Reference: Updated technical memorandum addressing agency comments on environmental reports for Site 3 of the National Capital Business Park, 4055 Russell Road, Ottawa

2.0 ADDRESSING OUTSTANDING COMMENTS ON THE MASTER-LEVEL ENVIRONMENTAL IMPACT STATEMENT

Figure 3 Map showing development setbacks for Site 3 based on environmental constraints

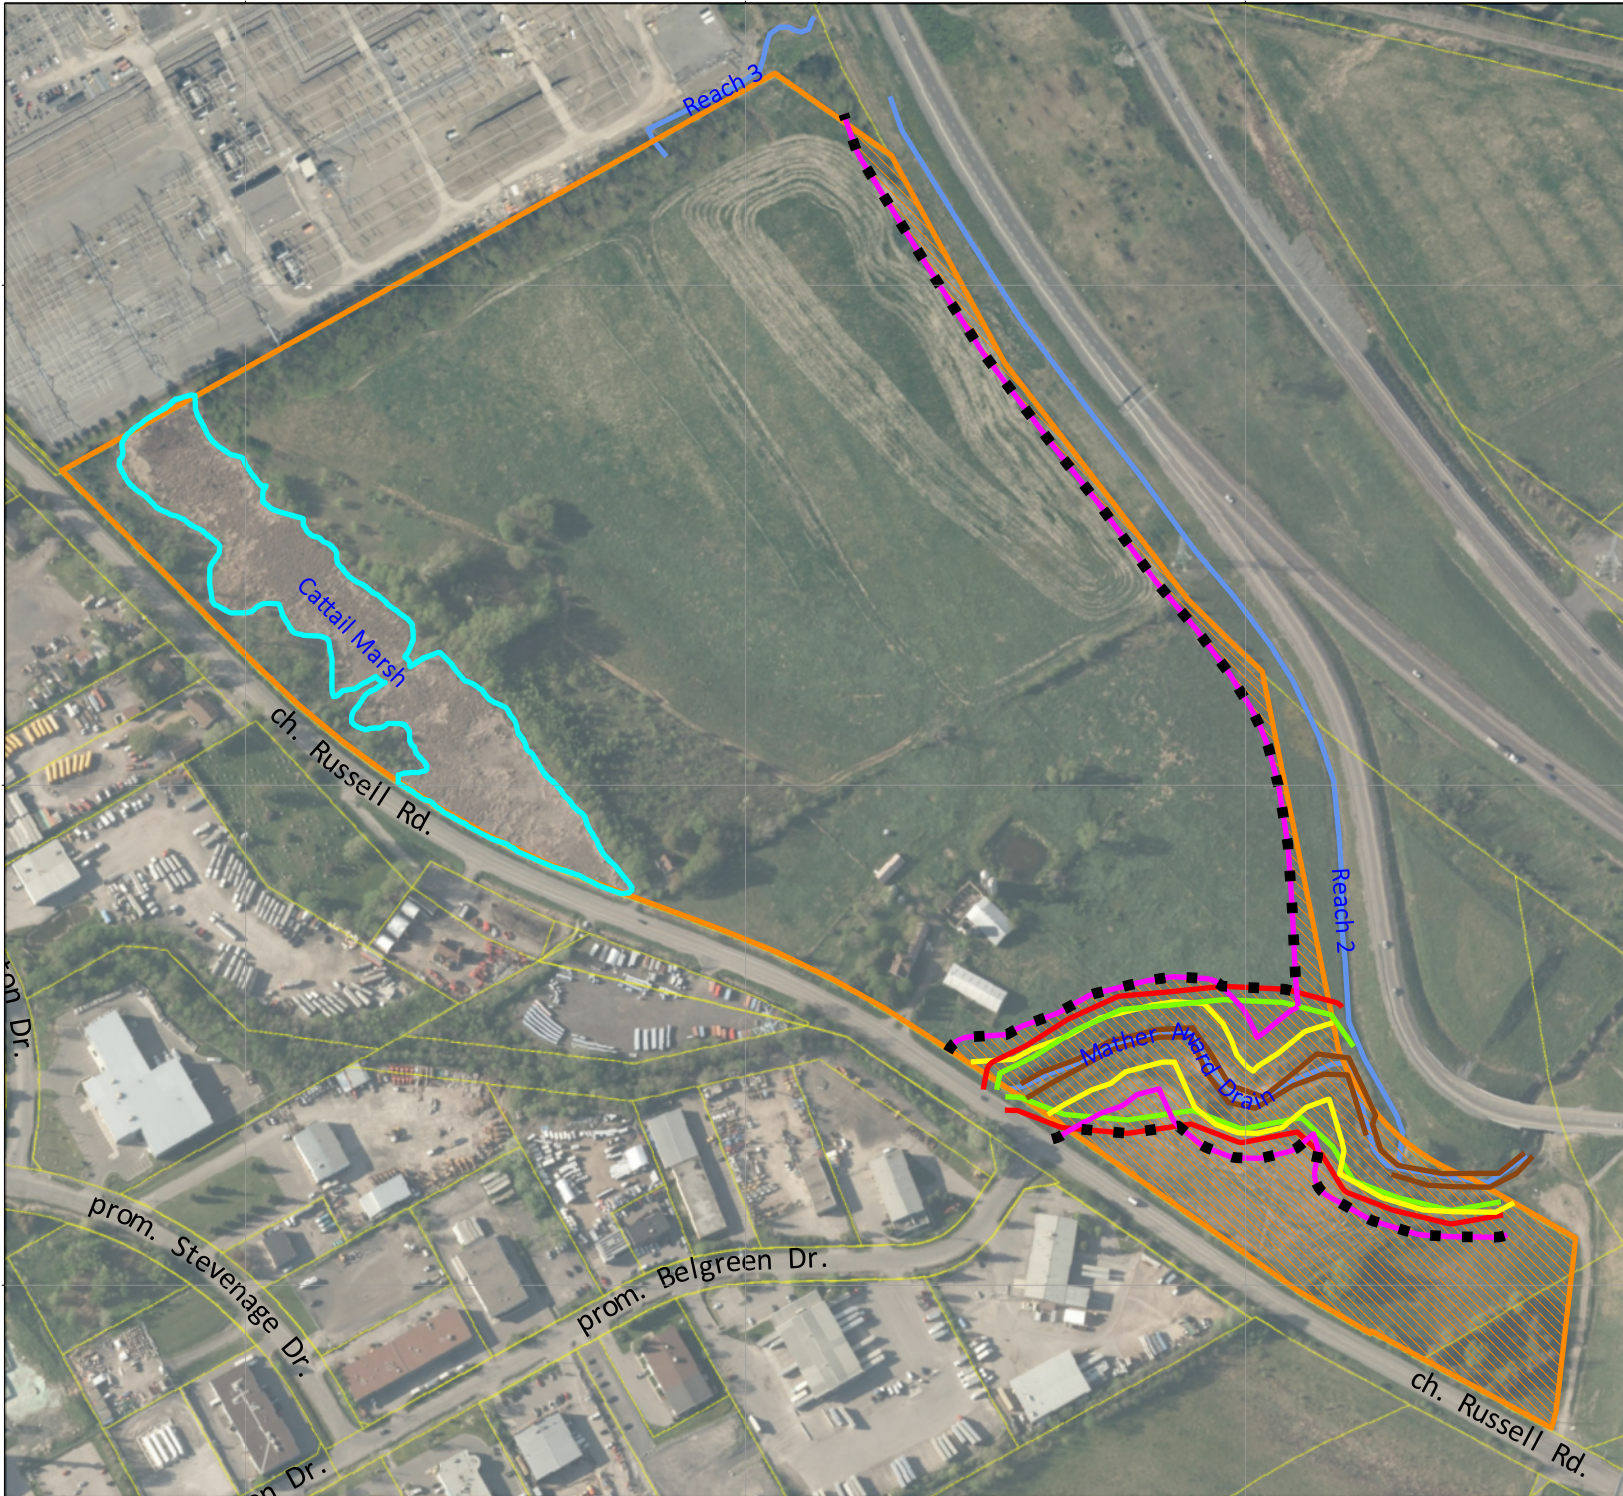
It is not clear on the plans provided what watercourse setback is being provided for Reaches 1 and 2. A site plan clearly identifying the 30 metre setback from the normal highwater mark for Reaches 1 and 2 (as identified in the Kilgour & Associates report) is required. The plan should also include the limit of hazard lands proposed by Paterson Group.

- Please see Figure 3 below.

- Please see the response to comment 101 from the RVCA above and Figure 3 regarding setbacks.
- Regarding the proposed stormwater outlet into the Mather Award Drain:
